SHEET 1 OF 8031-M-22 68			
CATEGORY A1

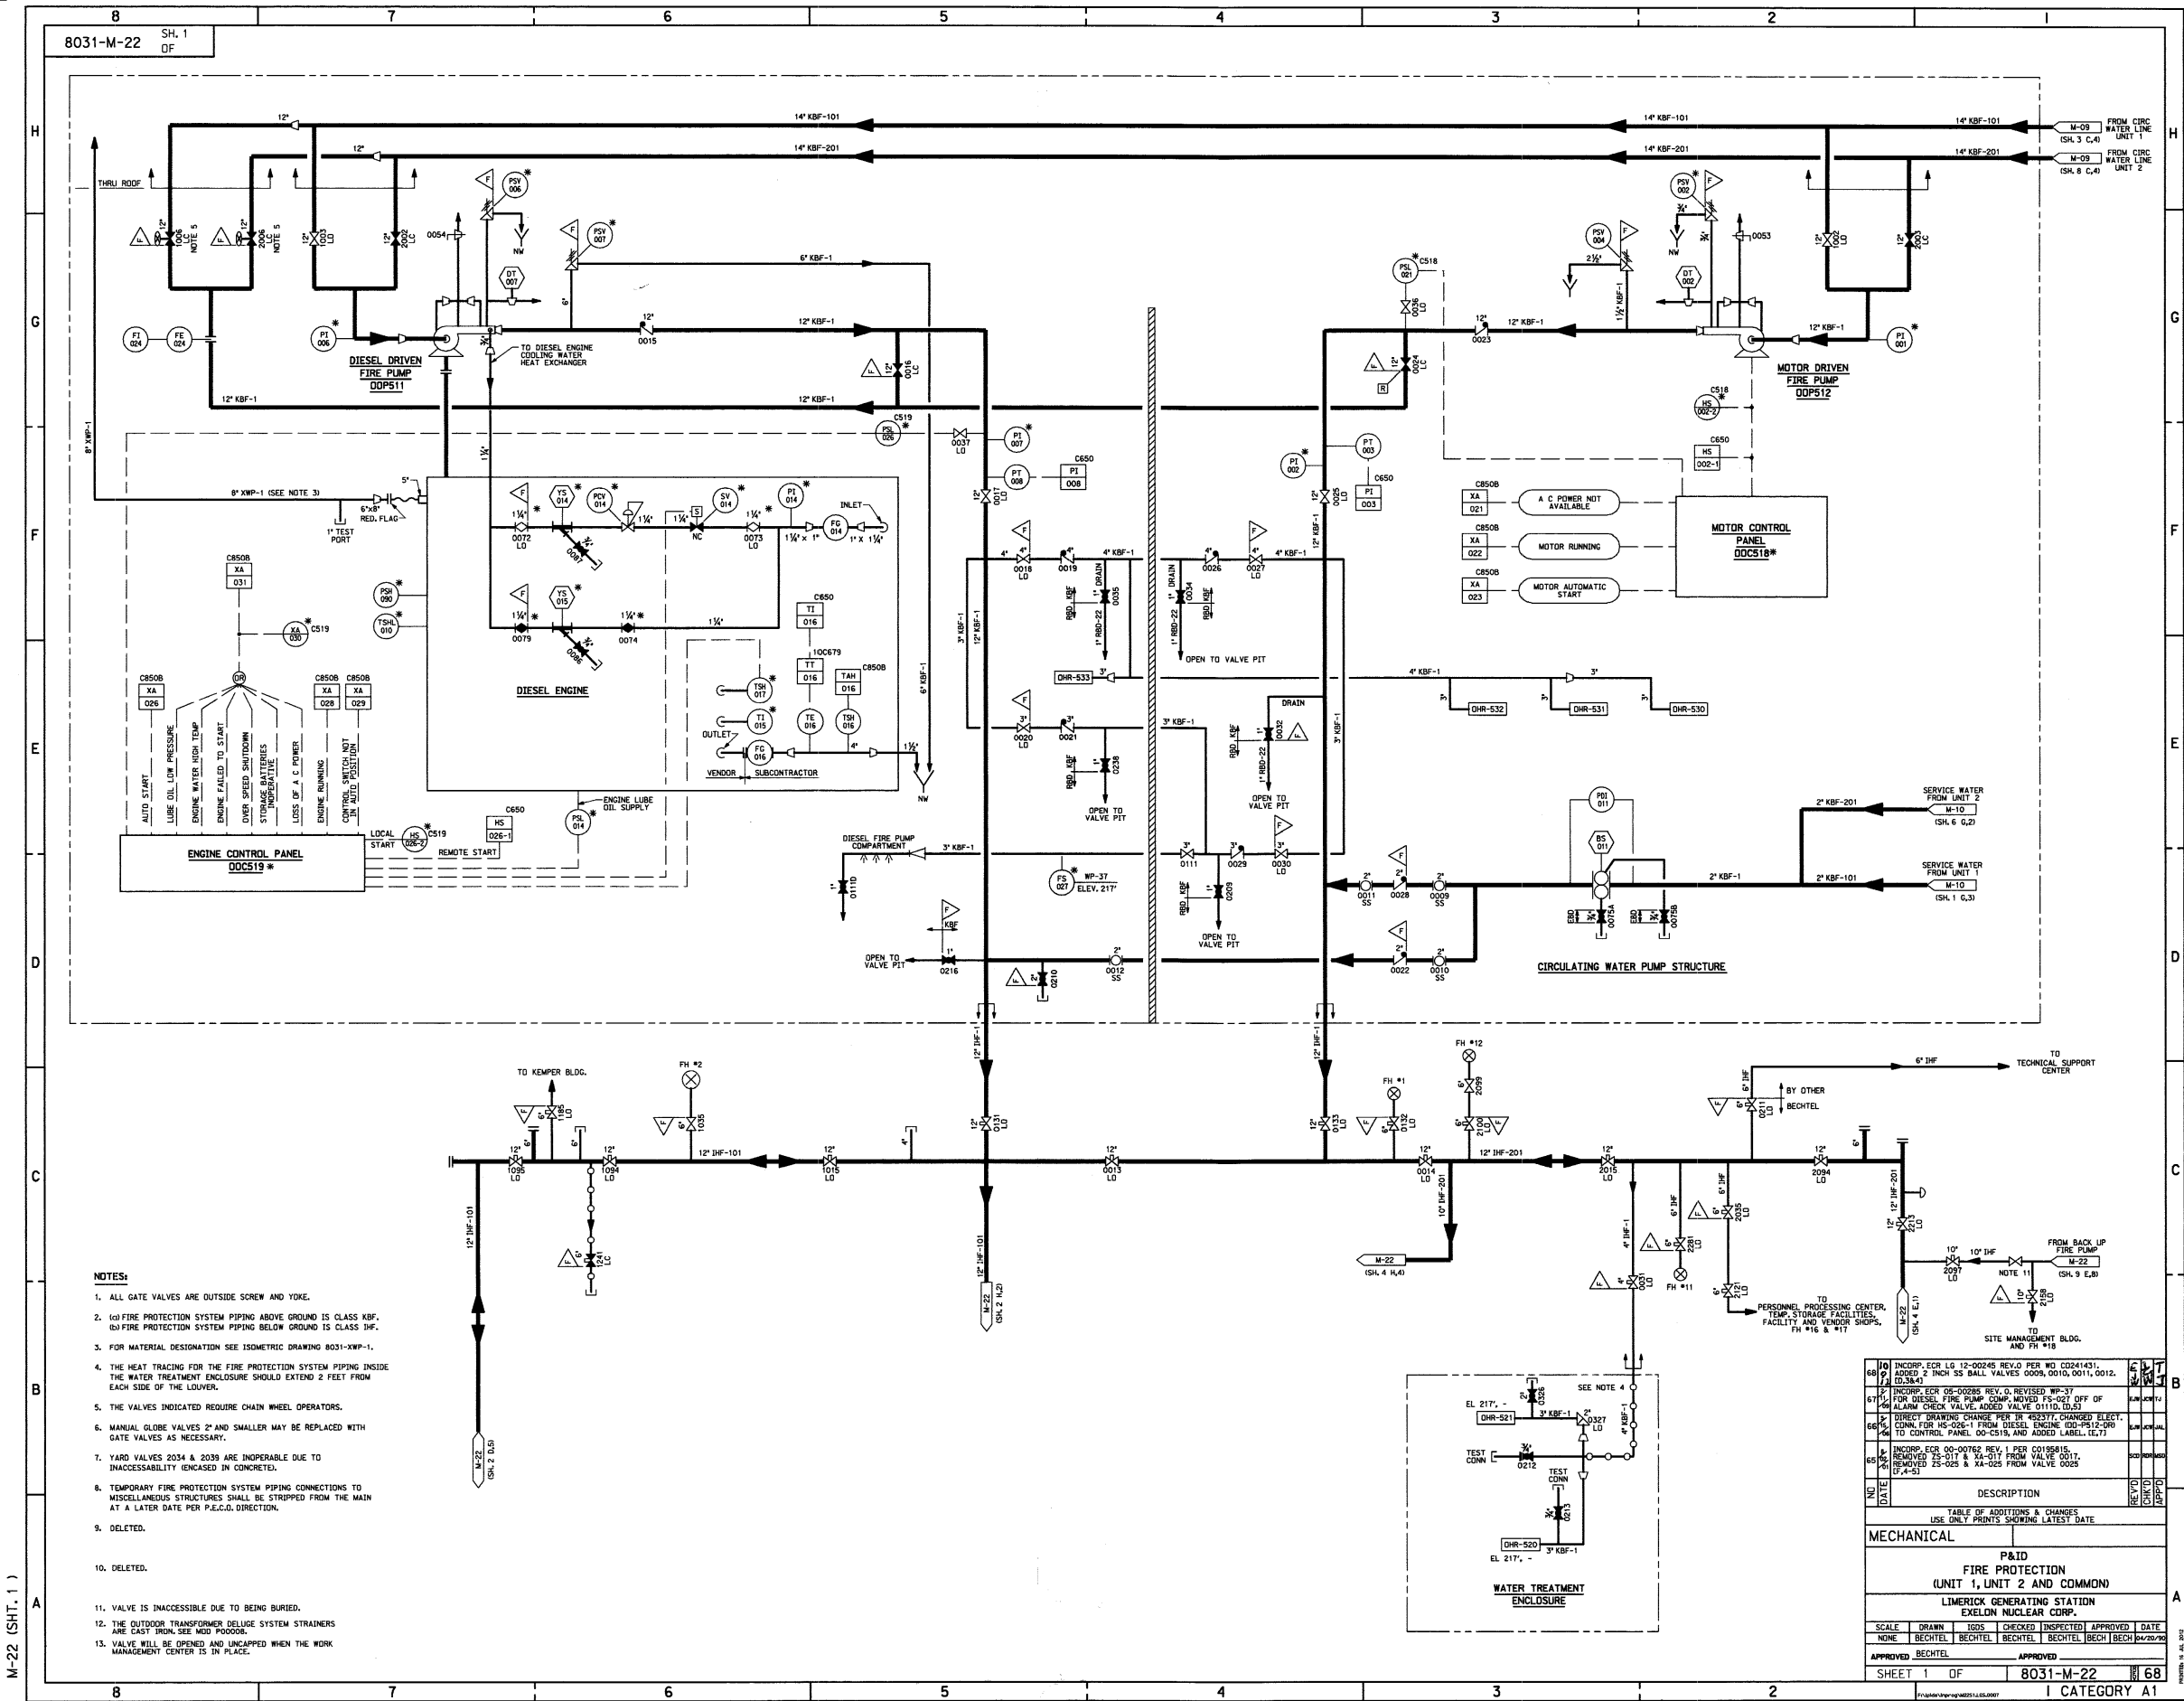
68	INCORP. ECR 12-00248 REV'D PER WD 00241431. ADDED 2 INCH SS BALL VALVES 0009, 0010, 0011, 0012. (D.S.K.)	6	1
67	INCORP. ECR 08-00285 REV. G. REVISED WP-37 FOR DIESEL FIRE PUMP COMP. MOVED PS-021 OFF OF MAIN ALARM CHECK VALVE. ADDED VALVE 01110. (D.S.)	6	1
66	DIRECT DRAWING CHANGE PER TR 423377, CHANGED ELEC. CONN. FOR HS-005-1 FROM DIESEL ENGINE (DO-PS12-DR) TO CONTROL PANEL DO-C515, AND ADDED LABEL 12.73	6	1
65	INCORP. ECR 00-00762 REV. 1 PER 00195815. REMOVED ZS-017 & XA-017 FROM VALVE 0017. REMOVED ZS-025 & XA-025 FROM VALVE 0025 (J.A.S.)	6	1
REV'D	DESCRIPTION	REV'D	APPROV'D
DATE	TABLE OF ADDITIONS & CHANGES USE ONLY PRINTS SHOWING LATEST DATE	DATE	APPROV'D
MECHANICAL			
P&ID			
FIRE PROTECTION			
(UNIT 1, UNIT 2 AND COMMON)			
LIMERICK GENERATING STATION			
EXELON NUCLEAR CORP.			
SCALE	DRAWN	ISSUED	CHECKED
NONE	BECHTEL	BECHTEL	BECHTEL
APPROVED	BECHTEL	APPROVED	BECHTEL
